HISTORIC AND DESIGN REVIEW COMMISSION

December 19, 2018

HDRC CASE NO: 2018-622
ADDRESS: 914 LAMAR ST
LEGAL DESCRIPTION: NCB 1655 BLK C LOT 11
ZONING: R-5
CITY COUNCIL DIST.: 2
DISTRICT: Dignowity Hill Historic District
APPLICANT: Andrea Frias
OWNER: Juan and Oralia DeLeon
TYPE OF WORK: Front porch modifications
APPLICATION RECEIVED: December 05, 2018
60-DAY REVIEW: February 04, 2019
REQUEST:

The applicant is requesting a Certificate of Appropriateness for approval to replace Folk Victorian porch elements with square columns, cattle panel fencing, and 2x6 wood decking.

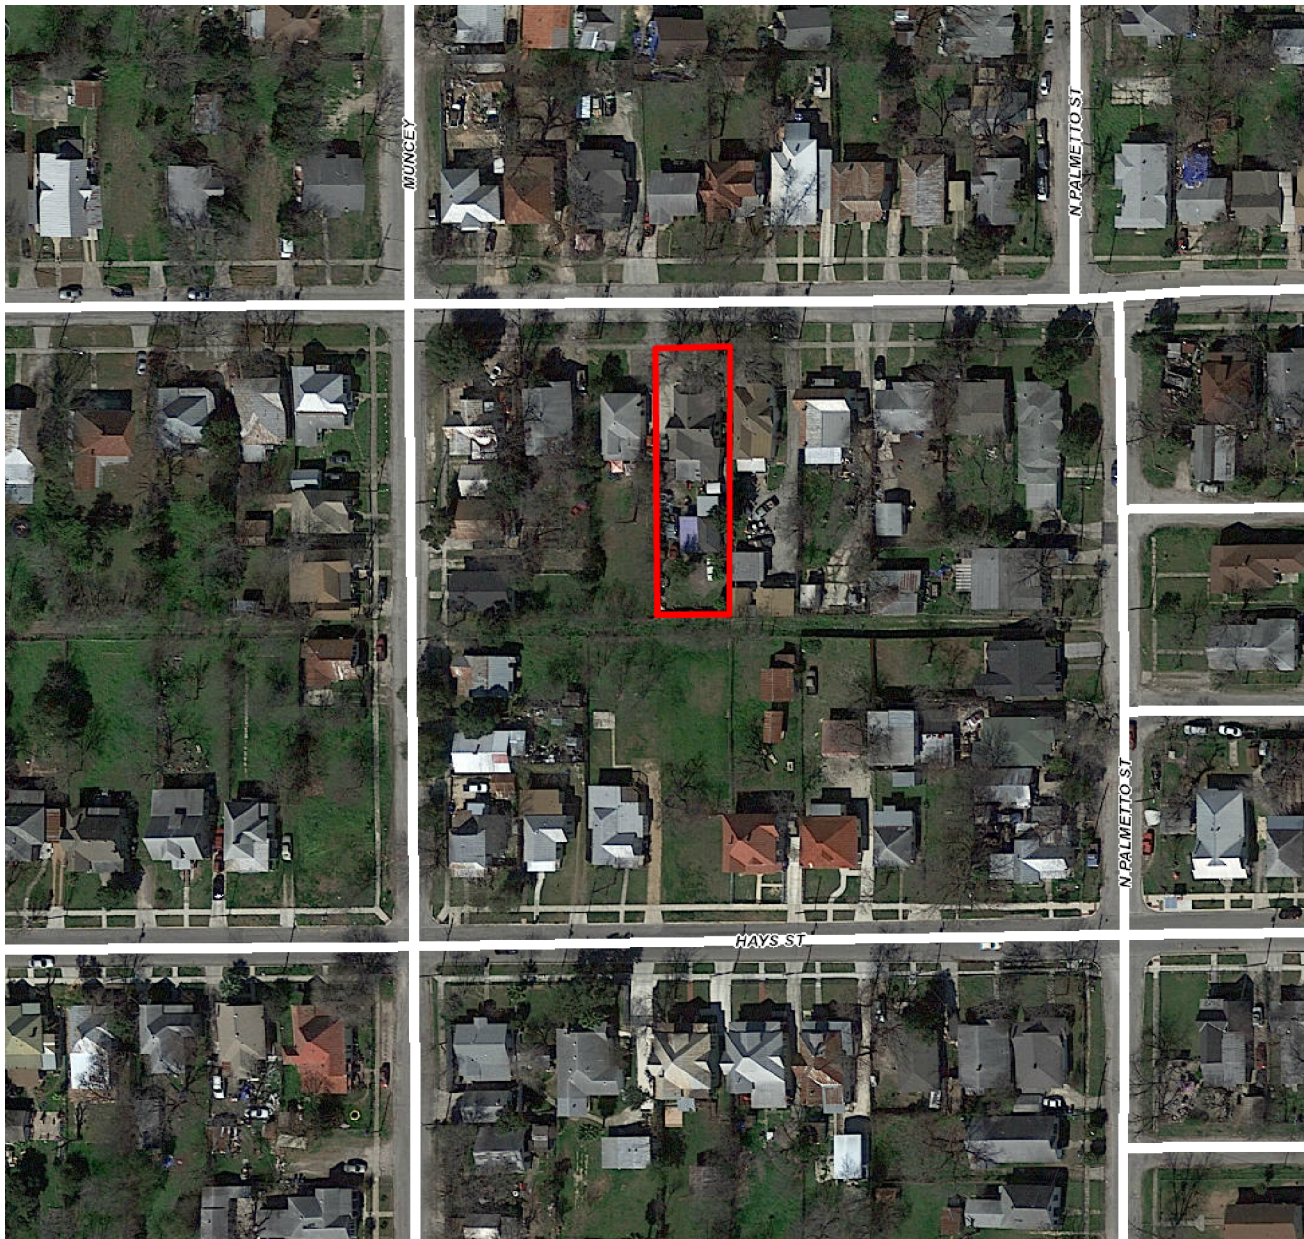
- c. **PORCH** – The applicant has proposed to remove the turned columns, spindle railing, tongue-and-groove decking with the square columns, cattle-panel fencing, and 2x6 decking. Per the Guidelines for Alterations and Maintenance 7.B.iii, porches and their elements should be replaced in-kind when deteriorated beyond repair. Staff finds that the columns were repairable and that three replacement elements are inconsistent with the Guidelines. Staff is unable to verify the condition of the decking prior to removal, but finds that a traditional 3” tongue and

groove would be more consistent with the Guidelines.

Staff does not recommend approval of the porch modifications based on finding b and c. Staff recommends the reconstruction of the original porch configuration featuring:

- i. Salvaged turned wood columns
- ii. Wood spindle railing at a similar height as seen in photographic documentation
- iii. Tongue-and-groove wood decking no wider than 3”
